<b>Subject:</b>  <b>ABNORMAL NOISE FROM THE FRONT SUSPENSION WHEN DRIVING ON ROUGH ROADS OR GOING OVER SPEED BUMPS</b>	<b>Bulletin No.:</b> 02-001/26
	<b>Last Issued :</b> 04/29/2026

Front Lower Arm (Rear) (1)

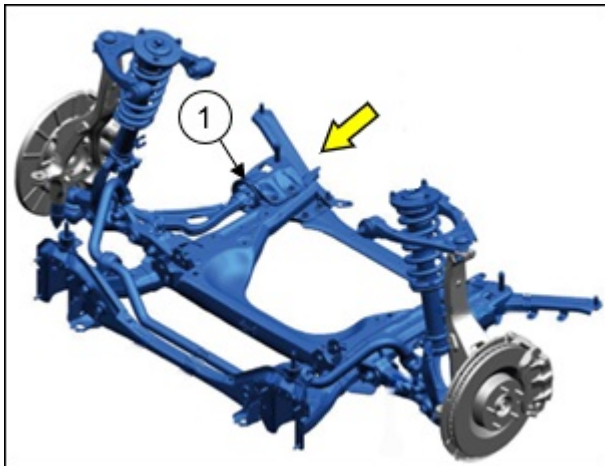
Some customers may complain that an abnormal noise is heard from the front suspension when driving on rough road surfaces or when passing over speed bumps. This is caused by insufficient heat resistance of the bushing material under specific operating conditions, resulting in cracking and fluid leakage in the front lower arm bushing.

View of Yellow Arrow showing cracked bushing

- The bushing material has been changed to a heat-resistant material.
- The bushing shape has been modified to reduce deformation.
- The damping characteristics of the front lower arm bushing have been modified.

- If noise is detected, replace the front lower arm (rear side) according to the instructions in MGSS.
  - CX-90 (FRONT LOWER ARM REMOVAL/INSTALLATION)
  - CX-70 (FRONT LOWER ARM REMOVAL/INSTALLATION)
- If NO noise is detected, this TSB is NOT applicable.
